SUBJECT: ACRS ASSESSMENT OF THE QUALITY OF SELECTED NRC RESEARCH
PROJECTS- FY 2009

Assessment of the Quality of Selected NRC Research Projects by the Advisory Committee on Reactor Safeguards - FY 2009

Figure 2. Examples of unreadable or overly busy Figures in NUREG/CR-6964 report

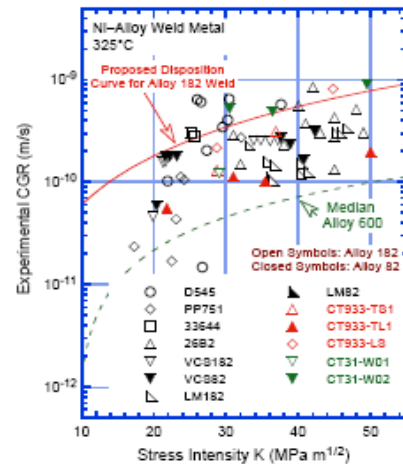
While the main body of the report is generally well written, there are other deficiencies in the report presentation. For example, Figure 13-b (see Figure 2) in the report is impossible to read. Many other figures such as Figure 29-b (see Figure 2) are overloaded with excessive and cryptic information which makes their review and evaluation needlessly laborious for the reader. The report also contains obvious errors which detract the reader from the main subject of the report (e.g. error on page 2 regarding the size of the Davis-Besse cavity being 50 x 70 inches!!).

Unreadable Figure 13-b

Overly busy Figure 29-b

Figure 3. Comparison of Figures 35a and 36 from NUREG/CR-6964 report

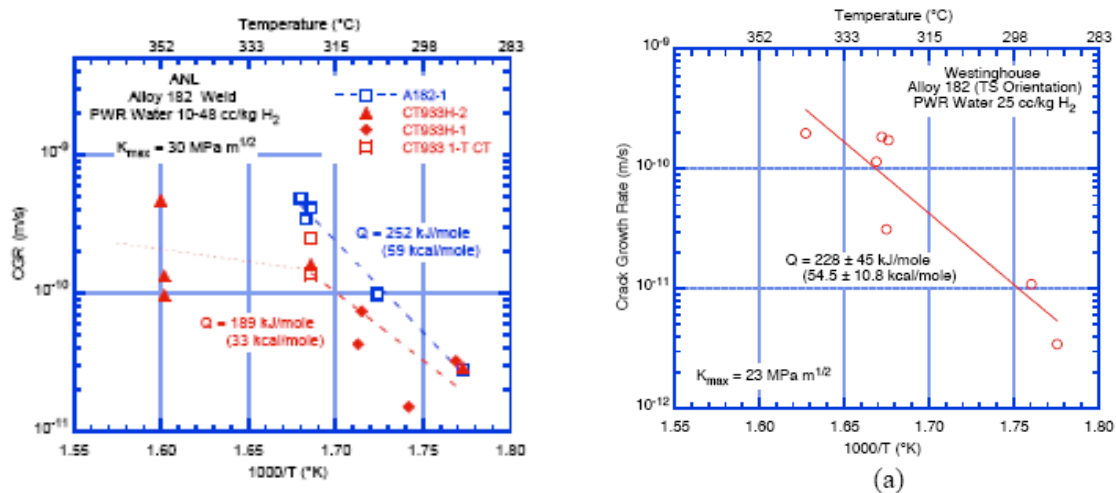
One of the major objectives of the new tests was to measure the influence of temperature on crack growth rates of A182 welds. The results of the tests are shown graphically in Figure 36 of the report, and reproduced here for discussion (See Figure 3). As displayed, the various intended and unintended variables used in these experiments make the evaluation of the results laborious. The red symbols represent test specimens taken from the deep groove weld,

and the blue from the double-J weld. The open symbols represent CGRs from 1T specimens and the filled symbols (red or blue) represent CGRs from ½ T specimens. Finally, the shapes of the symbols (triangles, squares, diamonds or rectangles) represent the four specimens in the test program. Consequently, one symbol on the graph represents four intended or unintended test variables.

For comparison, data from a similar study by Westinghouse requires only one symbol perhaps because the test variables were limited only to those necessary to determine the CGR of one type of weld, of one composition and one specimen geometry over the temperature range of interest.

The conclusions drawn from the ANL data plotted in Figure 36 are not particularly enlightening. While the activation energy for PWSCC crack growth in A182 double-J groove welds was in reasonably good agreement with other data in the literature, the CGRs determined from the tests of the deep groove weld, ½ T specimens exhibited considerable scatter. The CGRs from identical specimens (CT933H-1 and CT933H-2) tested over a 290°C to 320°C temperature range were inconsistent with the CGRs measured at the highest temperatures (352°C). No discussion was given as to the cause or significance of the large scatter in the CGRs at the highest temperature (352°C; see Figure 36), which were measured on the same sample (CT933H-2), at the same test conditions and in the same test facility. The CGRs determined in the highest temperature tests were excluded from the calculation of the activation energy. The authors contended the exclusion was justified because the data “suggest a plateau in CGR at temperatures above 320°C.” No further justification was provided for the unusual temperature dependence of this series of tests. The lack of agreement with the 1T double-J weld results, combined with the scatter in the data, and the unusual temperature dependence suggests that the entire set of ½ T deep groove CGRs should be considered suspect pending further analysis of the influence of the many variables involved.
